DATE: May 28, 2019
TO: Blue Bird Owners
Subject: RECALL R18ZO, Blue Bird Vision Alternator Cable Routing with Ford Engine

SUBJECT: RECALL R18ZO, Blue Bird Vision Alternator Cable Routing with Ford Engine

Alternator Cable Routing Vision With Ford Engine

A/C BRACKET ORENTATION CORRECTION

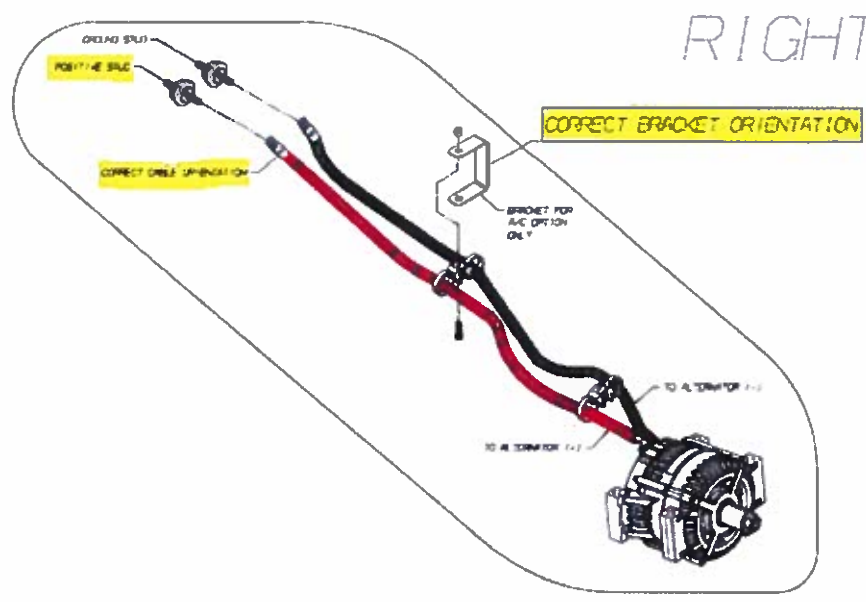
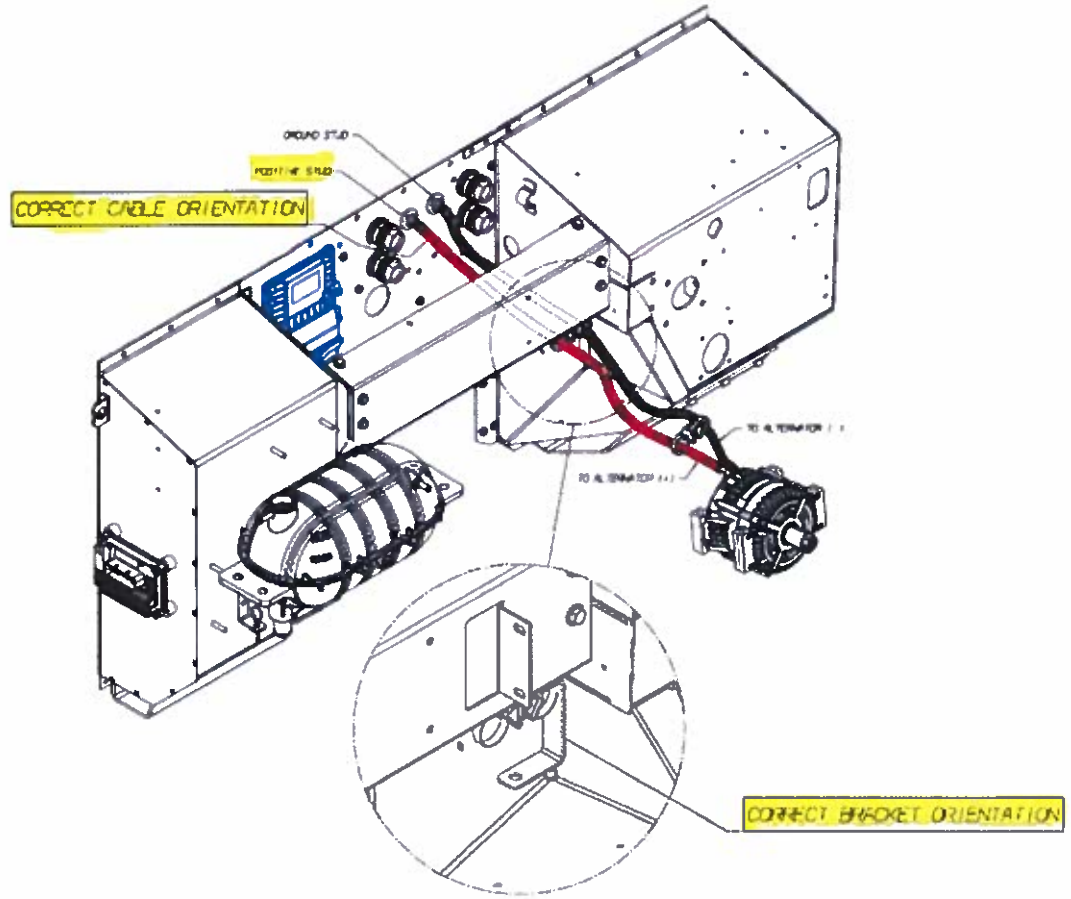
Inspect for proper clearance between the alternator cables and the air conditioning support bracket “if equipped”, and the DCM-to-Toe Box reinforcement channel. If required correct routing, per instructions provided below.

1. Park bus on a level surface, apply parking brake, remove ignition key, and chock wheels.
2. Disconnect Batteries: Note when disconnecting the batteries, remove negative cable first.
3. Inspect alternator cable routing per the illustrations on Pages 2 and 3. Insure that alternator cable and bracket for A/C option “if equipped” is oriented as shown on Page 2. Insure no contact with the alternator cables.
4. As a general guide maintain approximately ½ inch clearance gap between alternator cable and bracket for A/C option “if equipped”, and the DCM-to-Toe Box reinforcement channel.

5. If alternator cable orientation on positive stud requires correction, loosen the stud nut, reorient cable per “RIGHT WAY” illustration Page 2, and torque stud nut to 11-15 ft. lbs.

6. If bracket for A/C option orientation requires correction, loosen the attaching nut, reorient bracket per “RIGHT WAY” illustration Page 2, and torque attaching nut to 5-7 ft. lbs.
7. If reorientation in either step 5 or step 6 was required, inspect for any possible damage to the alternator cable. **If any damage is present, contact your local Blue Bird Dealer for replacement alternator cable.**
8. Reconnect batteries by connecting the negative cable last. Return bus to service.

RIGHT WAY

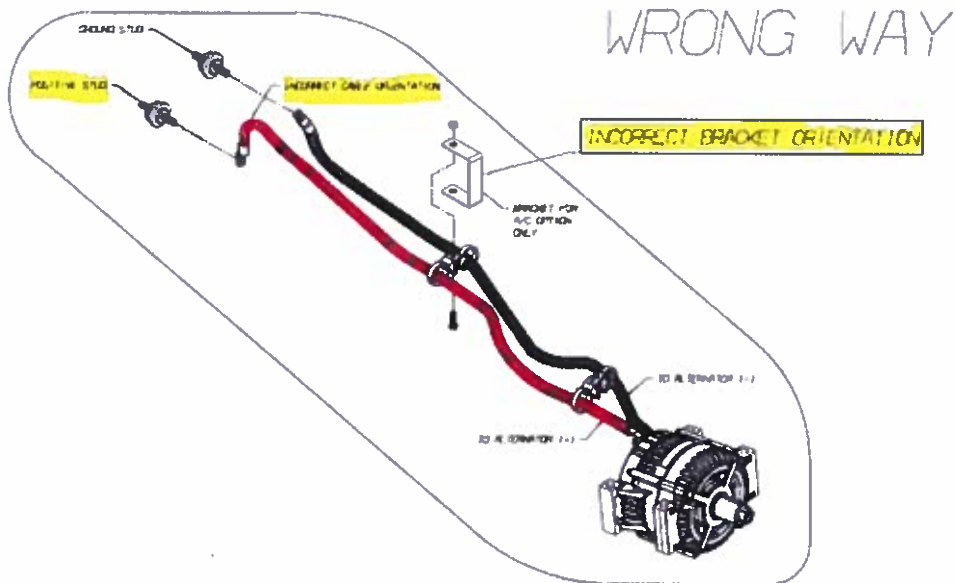
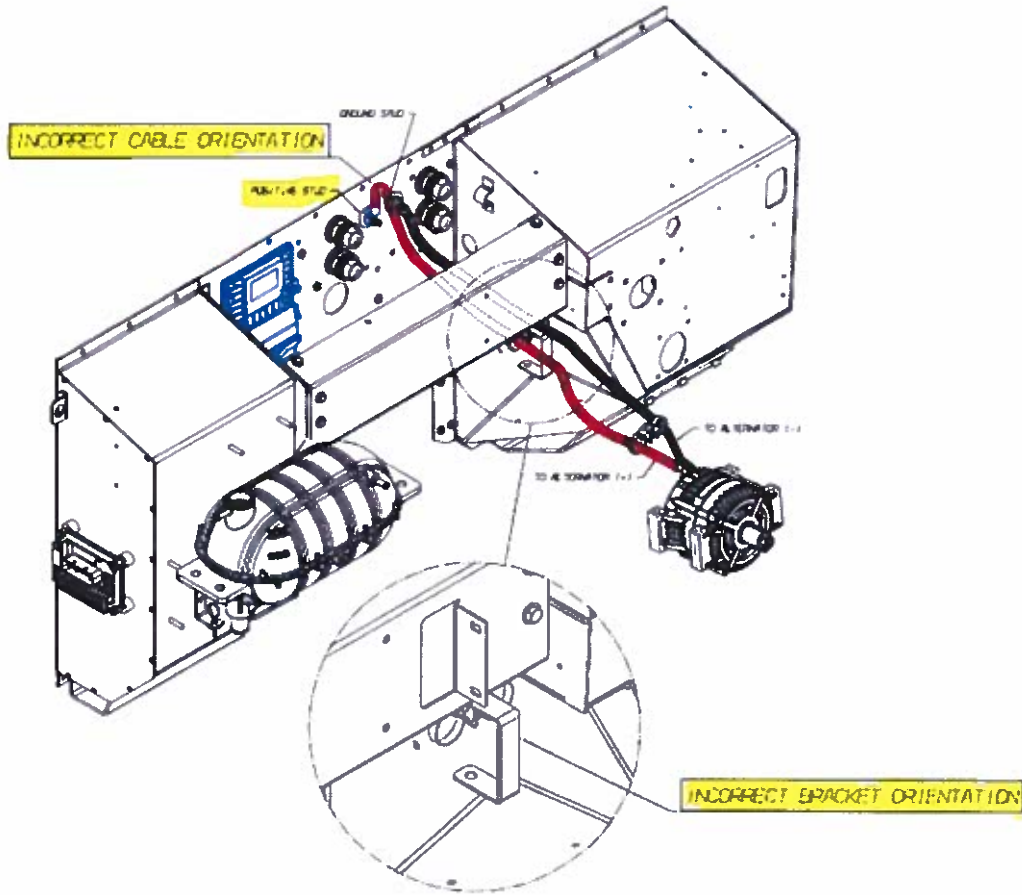
On certain 2017-2019 Visions with Ford 6.8L engines the alternator cables may not be routed correctly. The alternator cables may contact and potentially chafe against the air conditioning support bracket “if equipped”, and the DCM-to-Toe Box reinforcement channel.
